# Evaluation Report 179

## Noble Model NBB7623 (11.9 m) Blade Cultivator

# NOBLE MODEL NBB7623 BLADE CULTIVATOR

FIGURE 3. Blade Lifting Pattern: (A) Shear Bolt.

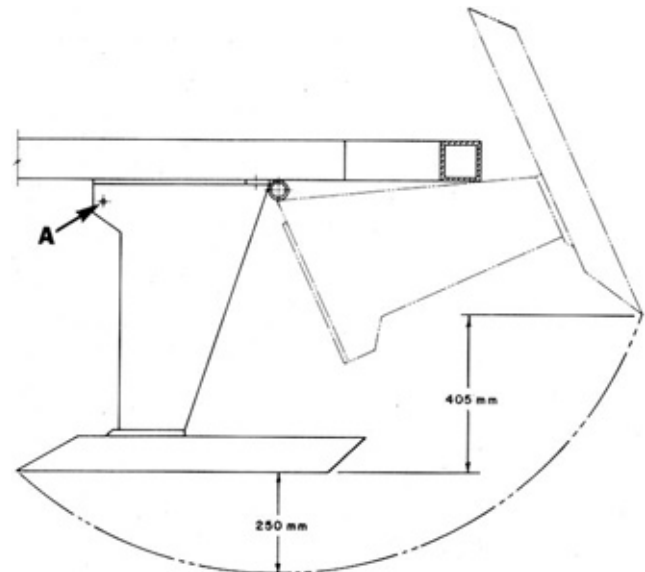
FIGURE 3 shows the lifting pattern when a shank encounters a stone or field obstruction large enough to cause the shear bolt to fail. Maximum lift height was 405 mm (16 in). From FIGURE 3 it can be seen that as the shank and blade assembly pivoted rearward, the blade nose had to move 250 mm (10 in) downward. This forced the frame to be lifted in hard soil conditions. Performance of the shank assemblies was fair. Two shanks and a rockshaft linkage failed when the shear bolt did not shear when a solid obstruction was

encountered. Modifications to reduce shank damage are recommended.

1. We are presently working on a self returning trip mechanism for the shank and blade assembly, it will allow the assembly to trip to the rear (without first swinging down) and also to the side to clear obstacles encountered on the wing of the blade.

FIGURE 4. Blade Pattern Showing Wheel Location, Shank Spacing and Blade Overlap: (A) Centre Section, (B) Centre Wing Sections, (C) Extension Wing Sections, (D) Outer Wing Sections.

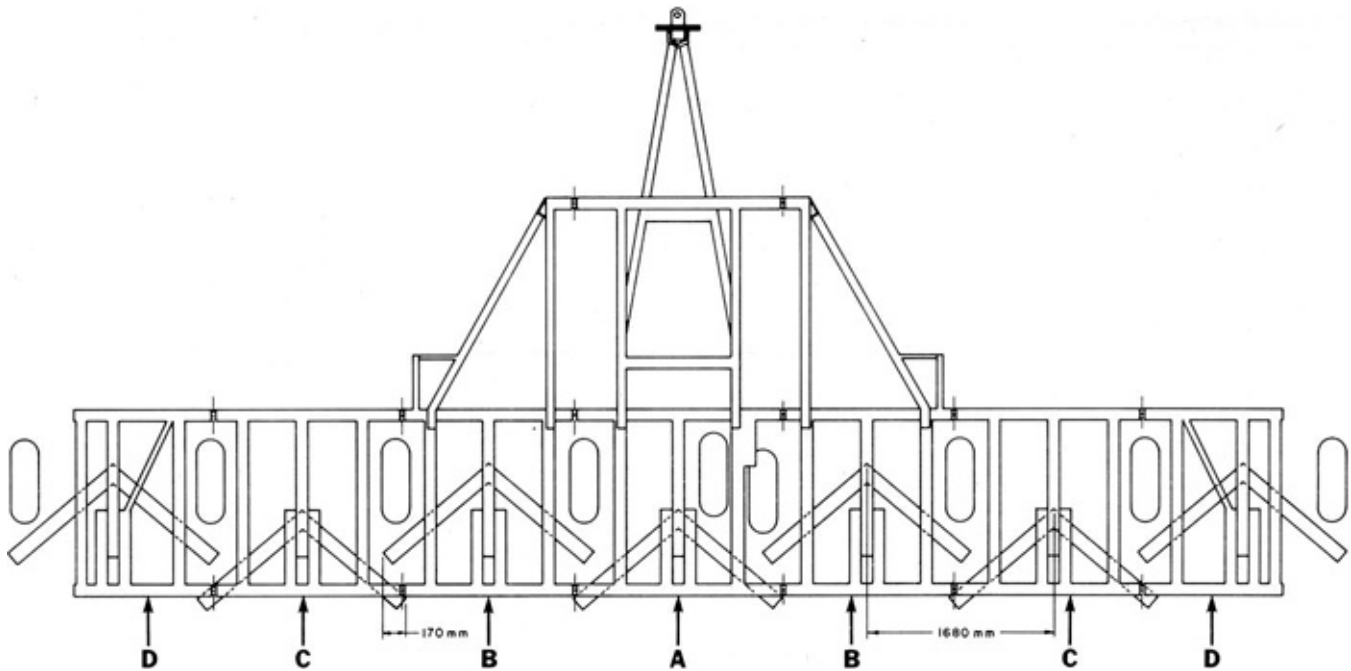
Tires were adequately sized to provide good flotation in all soil conditions. The wheels were positioned (FIGURE 4) so that each of the three centre section wheels supported about 12% of the cultivator weight, the right centre wing wheel about 16%, the left centre wing wheel 8%, each extension wing wheel 15% and each outer wing wheel 5%. In addition, the centre section wheels supported about 14% of the total tillage suction force, the two outer wing wheels 8% and all the other wing wheels 14%. For good flotation and uniform tillage depth across the width, it is desirable to have wheels sized and positioned so that each supports equivalent weight and a similar tillage suction force.

**Plugging:** Trash clearance was good. The Noble NBB7623 was capable of clearing medium to heavy trash. Plugging occurred in loose, heavy trash, between the dual centre wheels and the centre shank (FIGURE 5) which were only 205 mm (8 in) apart. Initial plugging at the centre shank was not always noticed as operator visibility of the centre shank was reduced by the centre weight box. Modifications to provide more clearance are recommended.

3. We are presently making the walking beam axles with stops to prevent overcentering. We have available a bolt-on strap to upgrade older machines.
4. There is a mounting location for the center shank at the extreme rear of the frame. Mounting the center shank in this location provides an additional 6 inches of clearance which should be enough to eliminate most plugging problems.

FIGURE 8. Interference Between Transport Locks and Depth Control Stop Collars.

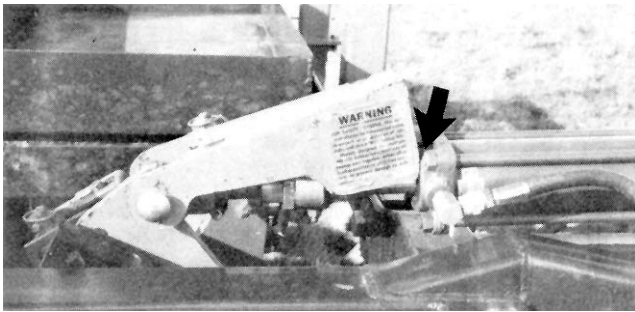
**Transporting:** The Noble NBB7623 was easily placed in transport position (FIGURE 7) using the hydraulic wing lift system supplied as standard equipment. Eleven pins, which had to be inserted by hand, were provided to fold and lock the wings for transport. Mechanical overcentre transport locks were also supplied for each depth control cylinder. Interference between the locks and fully extended depth control stops (FIGURE 8) prevented complete overcentre locking. It is recommended that the manufacturer consider modifications to eliminate this interference. Raising or lowering, depending on the tractor hydraulics, took one man less than ten minutes, providing there were no weights in the weight boxes. Weights had to be removed before raising the wings.

5. The overcenter lock has been modified to allow it to drop down over the depth control stops when they are fully extended.
6. We will provide a slow moving vehicle sign as standard equipment on upcoming runs. We also intend to have reflectors on the front and rear corners of the machine for safer night transporting.

FIGURE 10. Turnbuckle Pin Failure.

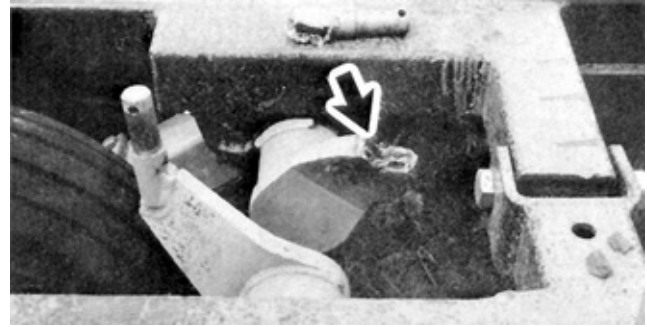
**Shanks:** One shank cracked and another was bent when the shear bolts failed to shear upon encountering field obstructions. This also caused failure of a turnbuckle rockshaft pin (FIGURE 10).
